DESIGN/DEVELOPMENT REVIEW COMMISSION
DESIGN REVIEW DISTRICT
HISTORIC AGENDA
EVALUATION SHEET
Case # 8

ADDRESS: S/S Longleaf Road, 3000 block

REVIEW DISTRICT: Melrose Heights/Oak Lawn Architectural Conservation District

NATURE OF REQUEST: Request Certificate of Design Approval for new construction

Façade submitted by applicant
(flipped by staff)

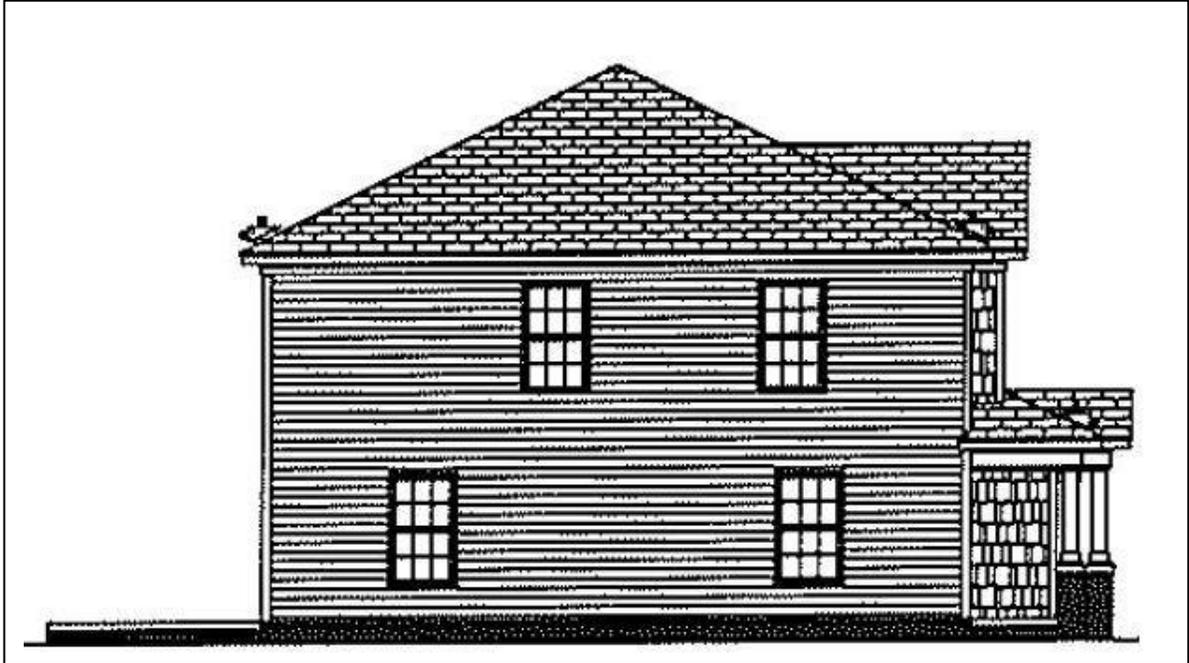
The massing of the proposed building is not compatible with historic two-story buildings in the district. It appears to be divided into two vertical halves that have little relationship to each other, as their massing is each different from the other. This disunity in the façade is unlike historic single-family homes in the district. There are other massing features that are not compatible with historic buildings. The first story projects out several feet beyond the second story along the right half of the building. The left half introduces a series of massing changes, with a slightly projecting second-story bay above a recessed porch. The enclosed portion on the porch projects from the façade and introduces a component not typically found on historic porches. These massing issues create a façade that is inconsistent with historic patterns.

Another component of the massing is the relationship of solid components like walls to open spaces such as windows and doors. On the façade, there are two, single upper story windows that are too small to replicate historic patterns. Just below these two windows are more typical-sized windows that do appear to match historic patterns. On the right elevation the first floor has a large, double-car garage door. This oversized opening is not found on historic buildings. Although the applicant moved the garage door from the façade to a side elevation, the side elevations of historic buildings in the district still do not feature such oversized openings. The garage door opening is also inconsistent with the massing of openings due to its requirement to disrupt the foundation wall. Openings in historic buildings are located within the wall plane, not the foundation wall. Due to the slope of the lots, the garage door will interrupt a somewhat tall foundation wall, and the top of the garage opening will be lower than typical window heights along the side elevation. This will

The house has a somewhat strong sense of entry due to the door's location and the surrounding porch, though the recess of the porch diminishes its strength slightly.

The rhythm of openings on the façade is somewhat consistent with rhythm of openings found on historic buildings, with at least one opening in each of the defined bays. The left elevation also has a somewhat typical rhythm of openings, although there is a large span (approximately 12 feet) between the windows on the first floor that is wider than patterns typically found in the district. The right elevation does not have a rhythm of openings consistent with typical patterns; the two windows are centrally located in the upper floor, leaving large blank walls, and the first floor wall is blank for the entire half of the wall. The large double-car garage door opening is unlike any feature found in the rhythm of openings in historic buildings in the district. Openings that large disrupt the established patterns found in the area; therefore the rhythm of openings does not meet the guideline.

The porch roof appears to introduce some unusual complexity and creates junctures between the various roof shapes that are not found in the area, for instance the hip roof of the porch is off-center in the projecting bay above it.

The shed or pent roof that stretches across the left half of the house above the first story is not found in the district. The proposed roof shapes and locations do not meet the guideline.

Porch: The porch has an overly complex roof form, which was discussed above. The form is due to the unusual layout of the porch, which is recessed, but has portions extending past the façade and then a small enclosure projecting even further. The front gable projection on the porch is very shallow, leaving perhaps a foot between the right column and the wall of the enclosure, which is not a typical porch depth. This layout is not visually compatible with porches found on historic buildings in this district.

Trim: The trim will be cement fiberboard. Only the small window on the porch is shown with trim surrounding the window. Trim is an important component of wood-sided buildings in the historic district, and to be visually compatible with historic buildings, trim board would be placed along the sides and tops of the windows on all three visible elevations of the building. A skirtboard separating the siding from the foundation would be a trim feature that replicates historic patterns in the district. The vertical corner boards already proposed are in keeping with the district, but the lack of trim around windows does not meet the guideline.

Door: The proposed door is fiberglass with an oval glass with etching. This type of door is not typical for the historic district. While the material will be indistinct once painted, the shape and character of the glass is not found on historic buildings nearby; therefore the proposed door does not meet the guideline.

Garage Door: The double-wide, metal garage door that is proposed will have glass in the top row of panels, which would offer some slight massing relief from the solid block of the paneled door. A particular design for the door has not been provided beyond what is shown in the proposed plans, which is a simple multi-panel design. It appears that none of the historic homes in this neighborhood originally had integrated garages such as the one proposed. The detached garages that are present were typically single-car, though there are some later two-car versions. The doors proposed are not visually compatible with historic garage doors in the area and therefore they do not meet the guideline.

Right elevation, provided by applicant, flipped by staff

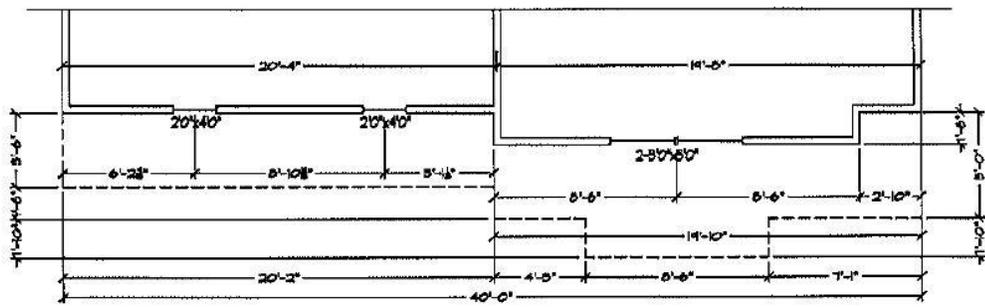
The large amount of solid space on the right elevation is also not typical of the area. Only two windows on this side are shown, one of them appears to be a ribbon window. These small horizontal windows are not generally found on a vast majority of historic buildings.

Siding: Cement fiberboard “clapboard” style siding with an approximately 6 ¼” reveal is proposed for most of the exterior and is a material that is visually compatible with the historic buildings in the district. The cement fiberboard “shingles” proposed for the right, projecting bay is not visually compatible. There is limited use of wood shingles in the district; it may be found in gables and covers one house completely on Hagood Avenue, but it is not used in this configuration on historic buildings. This use does not meet the guidelines.

Left elevation, provided by applicant, flipped by staff

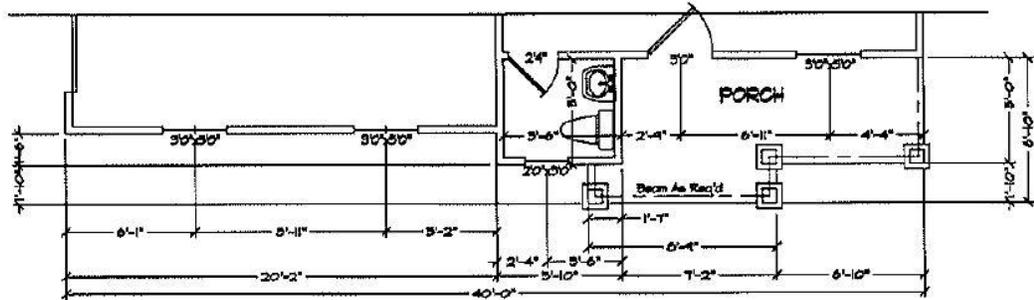
The left elevation has a massing that is more consistent with historic patterns, and features four full-sized windows that better fulfill the solid to void ratio that is typical of historic massing patterns in the district, however, a majority of the exterior has massing features that do not meet the guideline.

PROPOSED NEW RESIDENCE SITE PLAN FOR

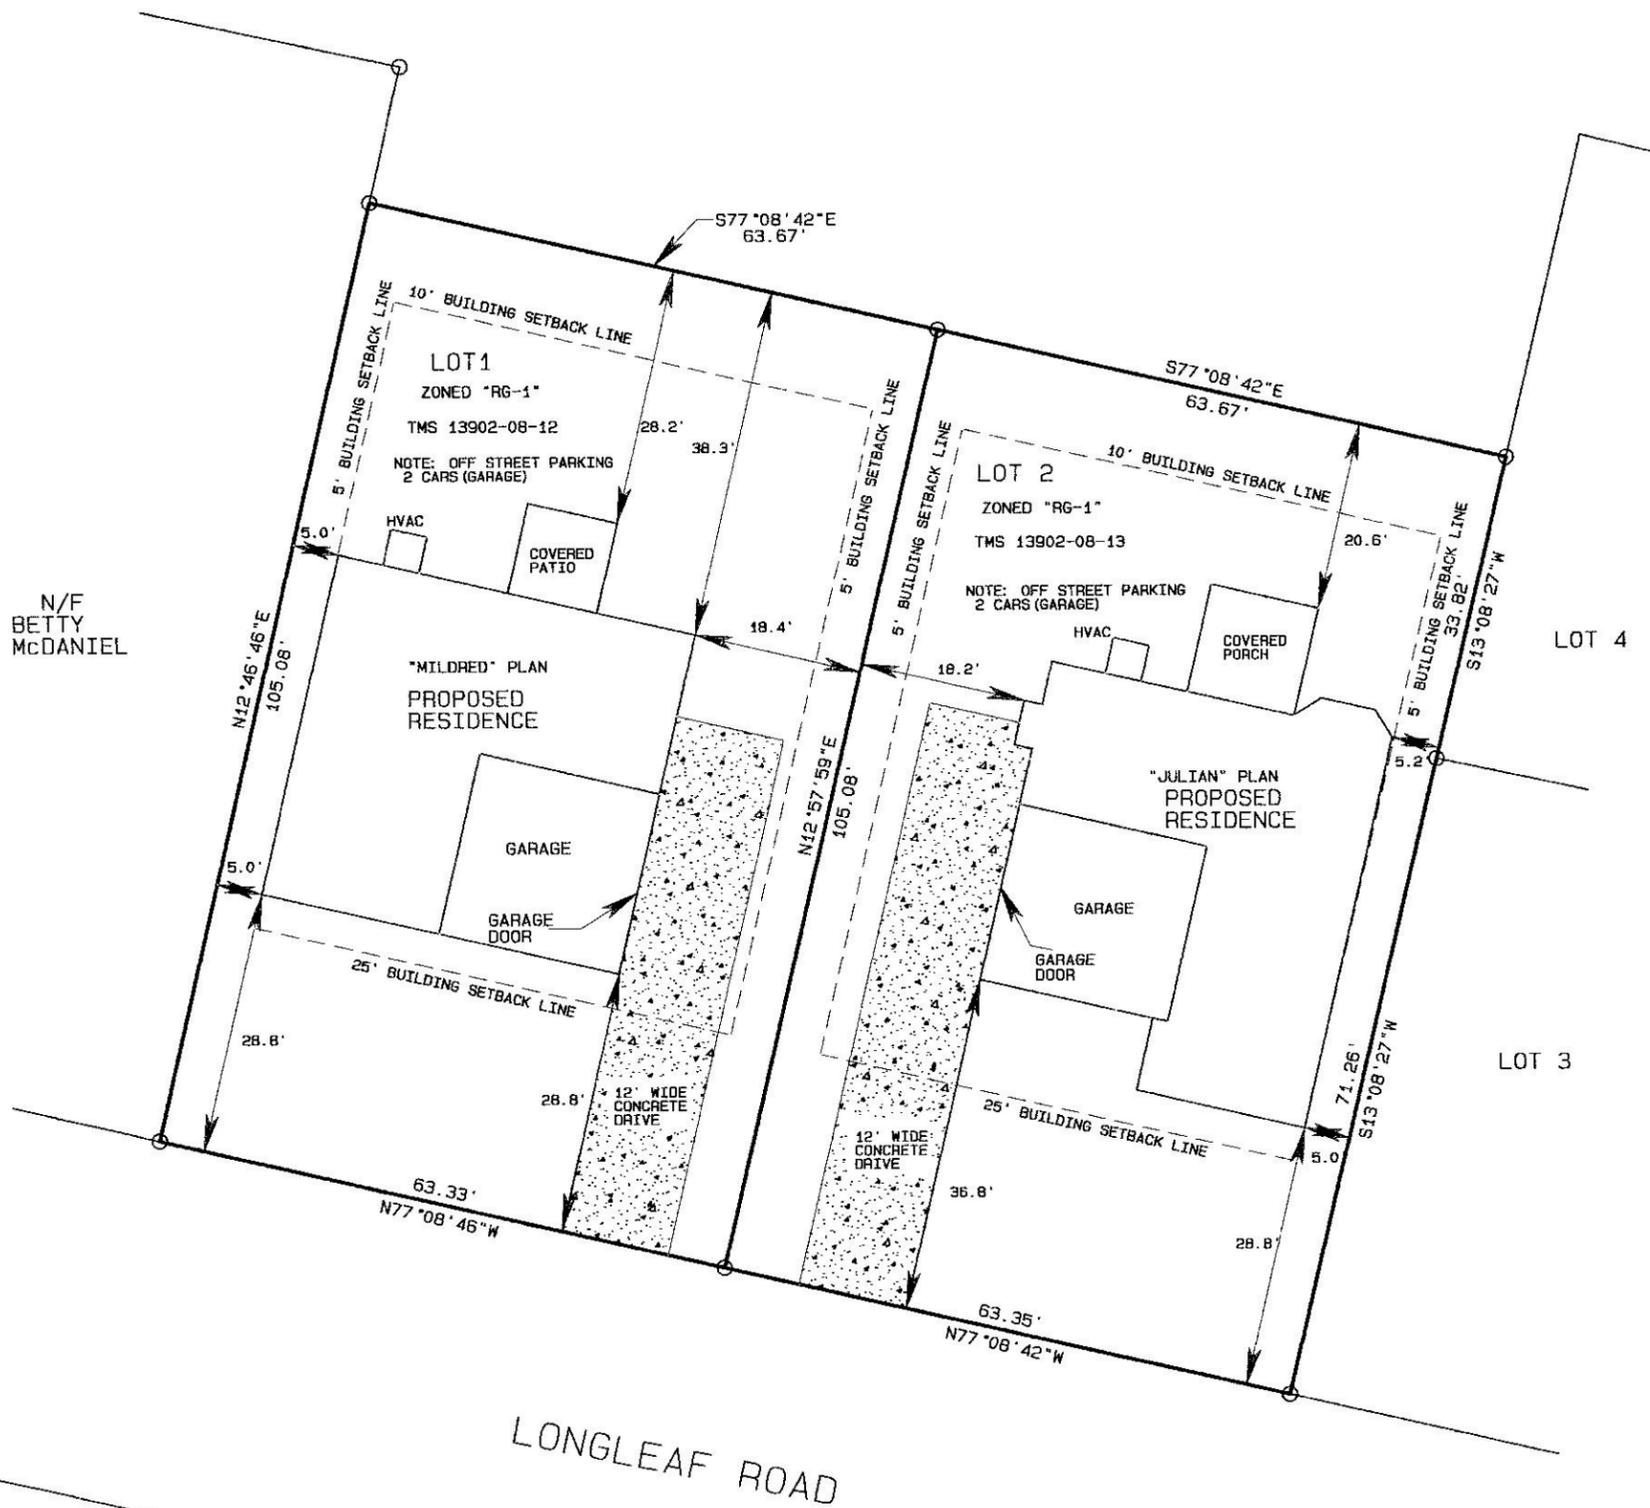
The height of the building is two stories, which is found in the district, however staff has not been provided measurements on the total height of the building. The site plan provided by the applicant does not indicate where the grading will occur and how it will affect the perceived height of the house, whether it will diminish or enhance it, so it is somewhat difficult to discern the actual height. The plans do not give an indication of the building's height to the roof peak; there are some exterior measurements suggesting each floor has an 8' height, but there is no measurement provided that includes the area between the floors, the foundation height, or the roof height.

Foundation Height: The elevations provided show a very short, brick foundation wall, which is not what is being proposed in terms of height. The applicant has indicated that they plan to do grading at the site but has not specified exactly how that will affect the proposed house. Due to the slope of the lot the proposed foundation height along the façade will be about 4'-8" at the left corner to about 3'-8" at the right corner; the left side will be about 4'-8" at front to ~3'-8" at rear; and the right side foundation will be about 3'-8" at front to ~1'-8" at rear. These measurements are approximate.
